Comments On The Administration's White Paper: "The Clinch River Breeder Reactor Project-- An End To The Impasse"

EMD-79-89
JULY 10, 1979

FOLLOW-UP QUESTIONS AND GAO RESPONSES
FROM MAY 31, 1979, TESTIMONY BEFORE THE
SUBCOMMITTEE ON ENERGY RESEARCH AND PRODUCTION
HOUSE COMMITTEE ON SCIENCE AND TECHNOLOGY

RELATIONSHIP OF ANNUAL URANIUM REQUIREMENTS
TO PROJECTED INDUSTRY PRODUCTION CAPABILITY

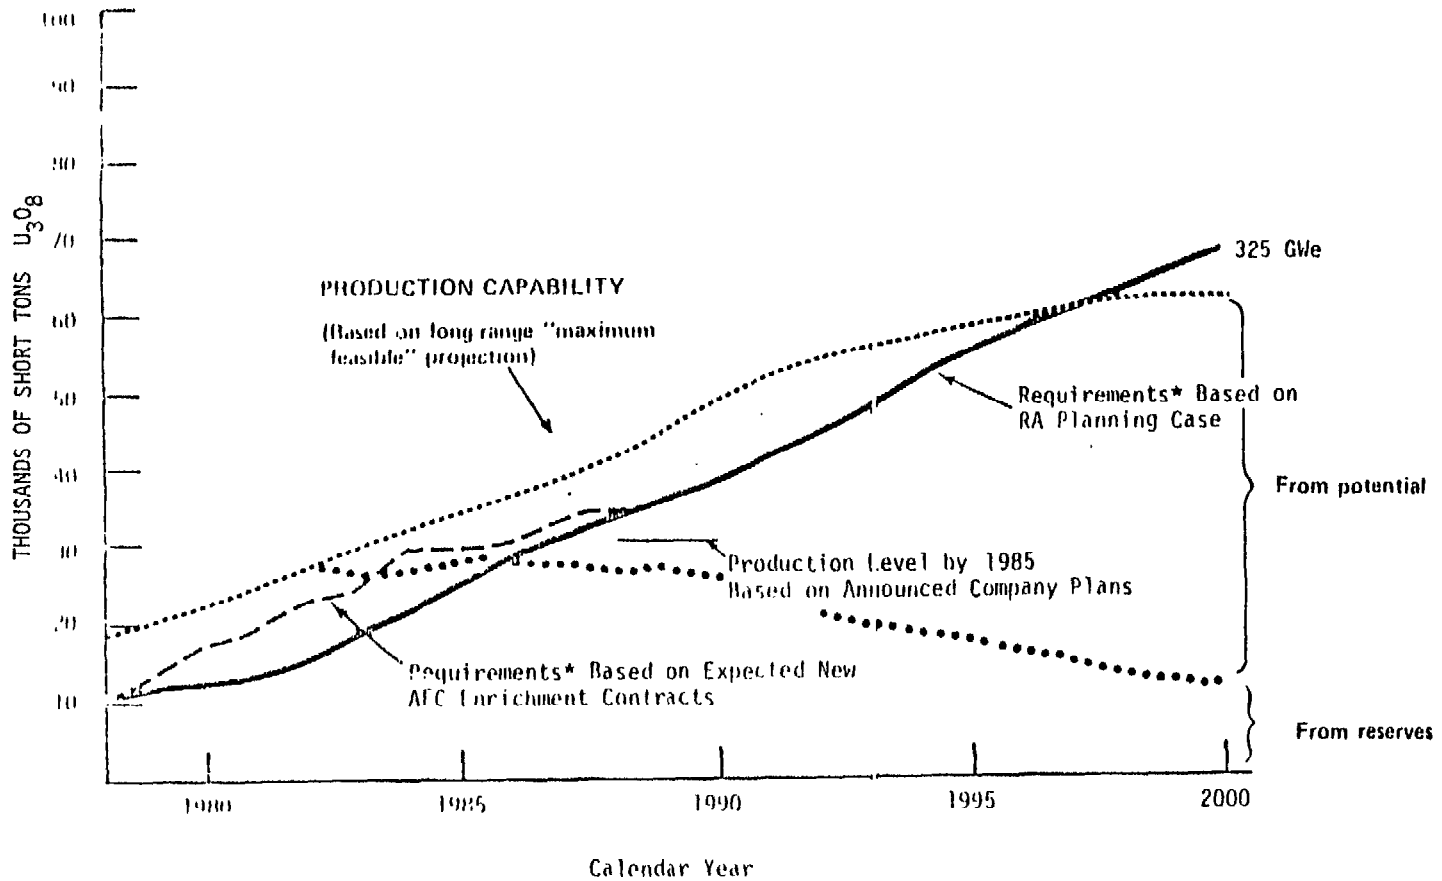
DOE's Assistant Secretary for Resource Applications testified on February 14, 1979, before this Subcommittee concerning the uranium enrichment and uranium resource assessment programs. In his testimony he included projections of uranium supply and requirements through the balance of this century. The projections in his Chart 11 (see page 5) appear to show a small shortfall of uranium beginning after 1997, with a total magnitude in the range somewhat under 10,000 tons of U_3O_8 over 4 years. However, this should be compared to projected use over those 4 years of more than 250,000 tons, to make clear that this potential shortfall is only some 3 or 4 percent of requirements. It is our view that projections two decades ahead should not

be expected to be precise enough to be read to this fine a level, but rather should be examined to detect major trends.

The significant trends in the data considered in the chart show a steadily continuing rise in uranium requirements, contrasted to a relative leveling out of production capability, which would suggest a gap that could grow to significant size in the beginning of the next century.

However, the chart indicates that the amount of U_3O_8 required for the balance of this century is about 800,000 tons, which is less than present estimates of uranium reserves alone, without considering any of the potential resources. Thus, the possible shortfall would not result from limited resources but rather because of the rate at which known uranium in the ground can be mined and prepared for use. Thus, because the White Paper considers only uranium resources and not mining and milling capacity, the estimated shortfall in uranium production does not have a direct bearing on the Paper's treatment of the question of breeder timing.
